**SHEARON HARRIS NUCLEAR POWER PLANT, UNITS 2 AND 3  
DOCKET NOS. 52-022 AND 52-023  
RESPONSE TO REQUEST FOR ADDITIONAL INFORMATION LETTER NO. 059 RELATED TO  
RADIATION PROTECTION DESIGN FEATURES**

**Shearon Harris Nuclear Power Plant Units 2 and 3  
Response to NRC Request for Additional Information Letter No. 059 Related to SRP  
Section 12.3-12.4 for the Shearon Harris Units 2 and 3 Combined License Application,  
Dated February 27, 2009**

**NRC RAI NUMBER:** 12.03-12.04-1

FIGURE 12.4-202

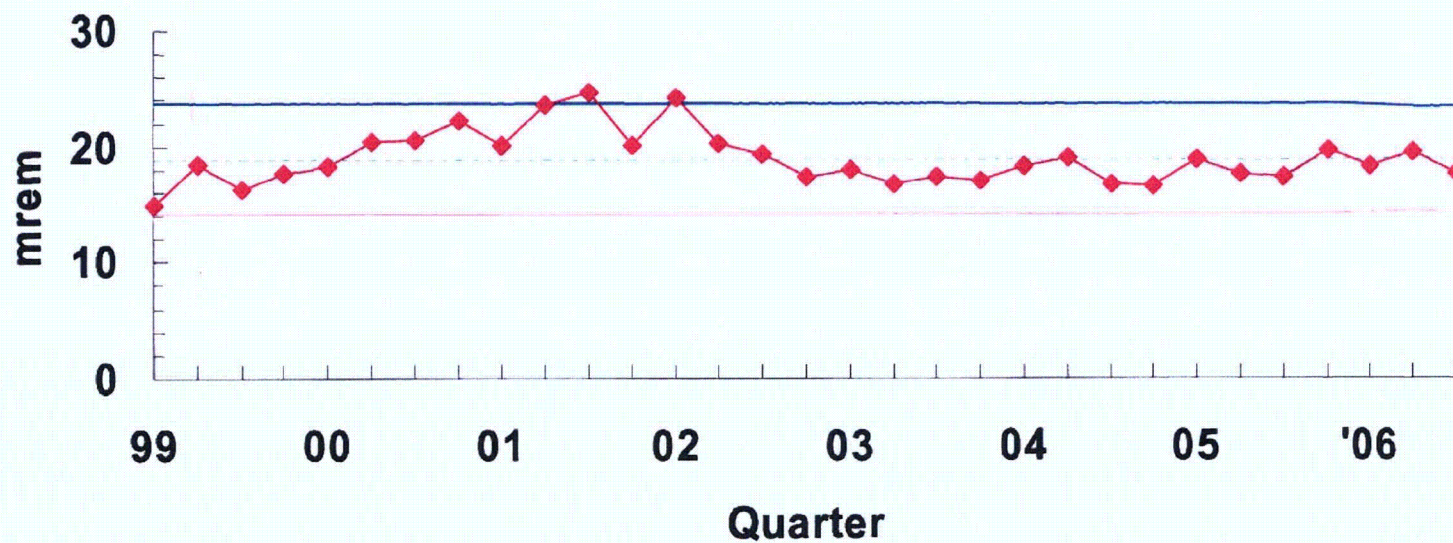
Harris COL FSAR Subsection 12.4.1.9 appears to use one year of environmental monitoring data from Thermo Luminescent Dosimeters ( TLDs) to evaluate the potential direct radiation dose to construction workers associated with Unit 1 & 2 operations. Please provide the following bases information:

- i) Sufficient bases information to demonstrate that the TLD data used is consistent with previous years of data collected and why the selected single year (2004) is appropriate;
- ii) Include a discussion in the bases of the effect of capacity factor for Unit 1 during 2004 on results;
- iii) The bases for detection level and error bounds for doses based on the single year of TLD Data that provide an estimate of construction worker exposure meeting the standards of 10 CFR 20.1301; and
- iv) A description of the specific TLD locations that are used to estimate the dose to construction workers and justification for the assumption that the selected TLD locations are representative of the exposure that is estimated to be received by the construction workers.

As can be seen from Environmental Report Figure 4.5-2, the maximum value of 24 mrem for a quarter is the plus 2 sigma value.

The maximum value of 24 mrem in 90 days is from the third quarter of 2001 and the first quarter of 2002 (See Environmental Report figure 4.5-2). As stated in FSAR Subsection 12.4.1.9.3, this works out to an exposure rate of 11.1  $\mu$ rem/hr. Assuming a 2080-hour work year, the annual radiation exposure to a construction worker is approximately 24 mrem. In addition, for the majority of the time during construction of the HAR facilities, the construction workers would be located much farther from the HNP operating radiation sources than the distances reflected in the protected area fence line TLD locations. The HAR facilities will be located outside the HNP protected area fence line and will be away from any HNP radiation sources.

New FSAR Figure 12.4-202 (Revision 0 Draft) – Average of the Protected Area Fence Line TLD Readings (1 page)
